ENGINEERING CHANGE NOTICE

1. ECN 169879

13b. Justification Details
 To update the Groundwater Monitoring Plan to document monitoring well placement for the 1993 drilling program. Locations are based on the Part B Dangerous Waste Permit (DOE/RL-88-27, Rev. 2), and discussions with Washington State Department of Ecology.

Figure 3.1. Map Showing the Locations of Existing and Planned Monitoring Wells at the Grout Treatment Facility.

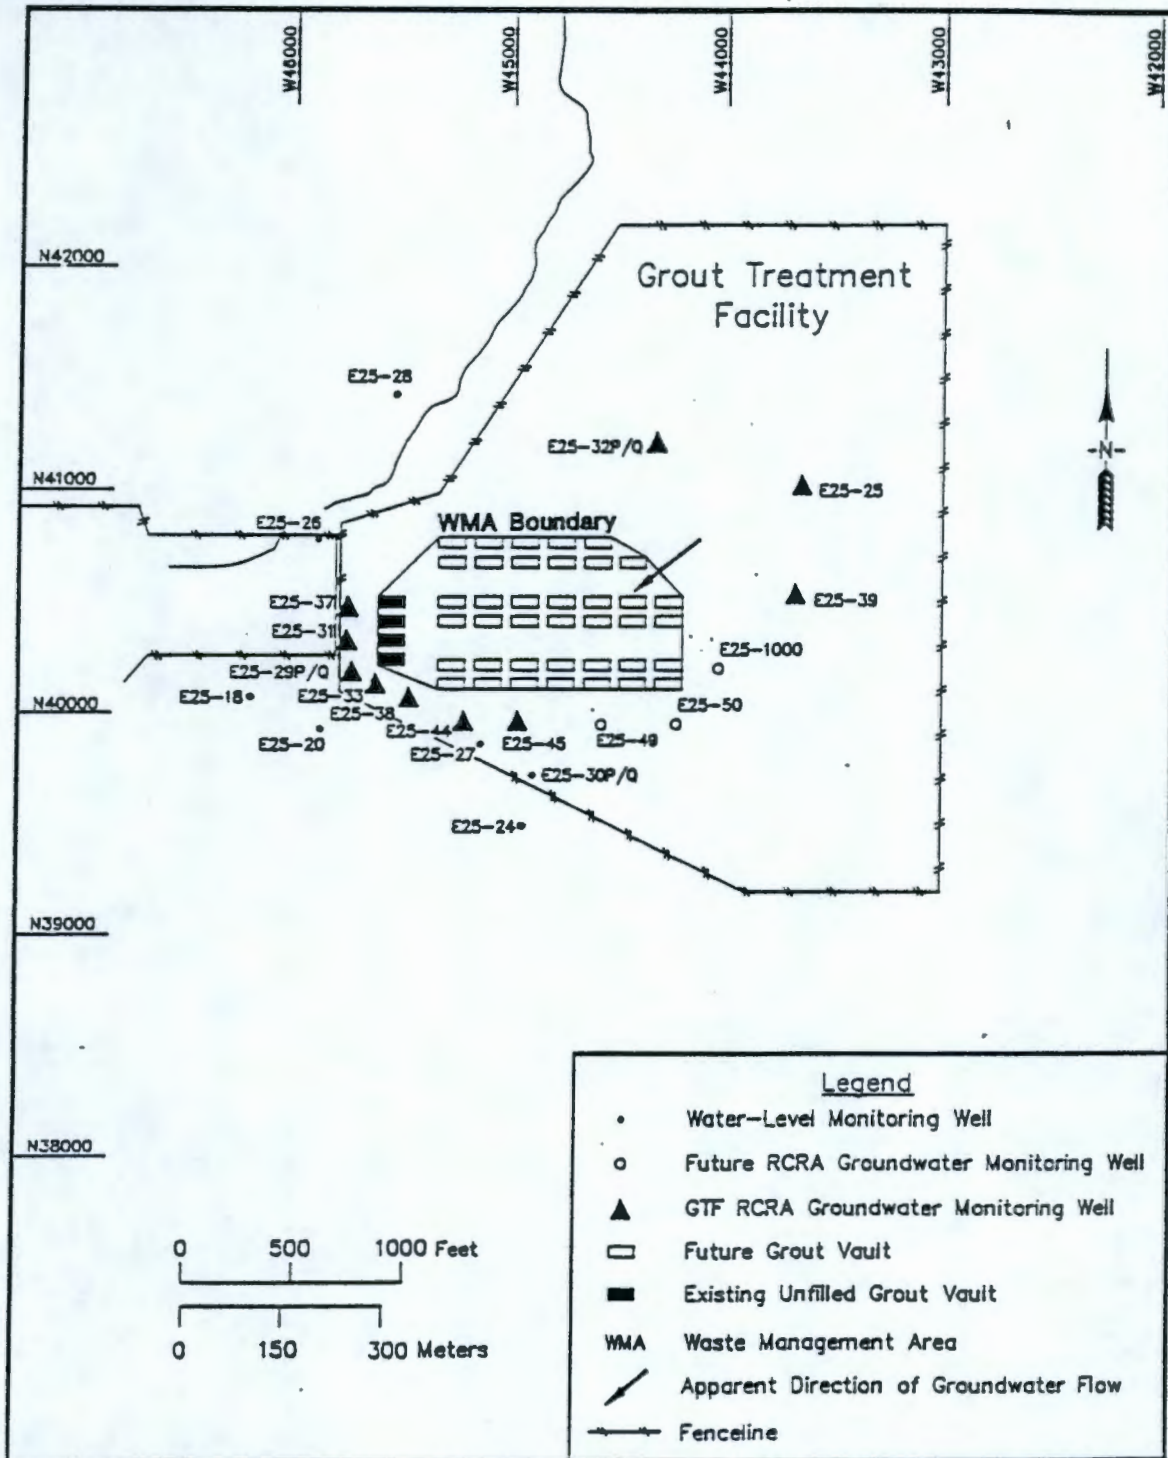
1. The paragraph added to page 55, in the section entitled, Installation of New Characterization/Monitoring Wells, should be revised and expanded to:
 Five downgradient wells are proposed for construction along the GTF point of compliance: two wells in 1992 and three in 1993. The 1992 wells will be spaced 250 ft apart and the 1993 wells 350 ft apart. The wells will continue along the line of compliance that extends southeast and then east of well 299-E25-38, with the exception of well 299-E25-1000 (Figure 3.1).

3. Another revision of Figure 3.1 (attached), page 50, should replace the one in the groundwater monitoring plan.
